Upgrade Style RX 300/600 230V Pilot lamp (E27 to GX6.35)

This document describes how to replace the Pilot lamp E27 socket by the new GX6.35 socket on the compact **Style 300RX 230V** and **Style 600RX 230V**.

Upgrade Process

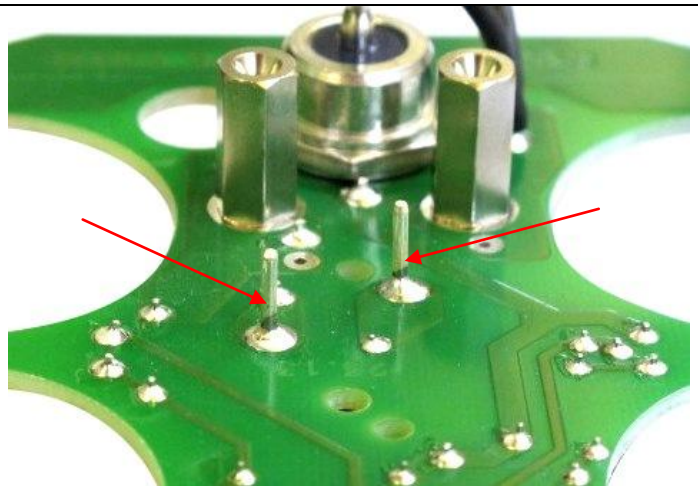
1. Be sure that the Style RX unit is discharged and disconnected from the mains before open.

2. Use a clean glove to remove the flashtube.
Remove the pilot lamp E27 and the inner reflector.

3. Remove the E27 socket on the board PB2 14373RX.
Do not remove the socket contacts on the board (see picture)

4. Mount the new inner reflector 659.006 and connect the lamp socket to the contacts on the 14373RX board.

5. Use a clean glove to plug the flashtube and the new pilot lamp GX6.35 (23034)
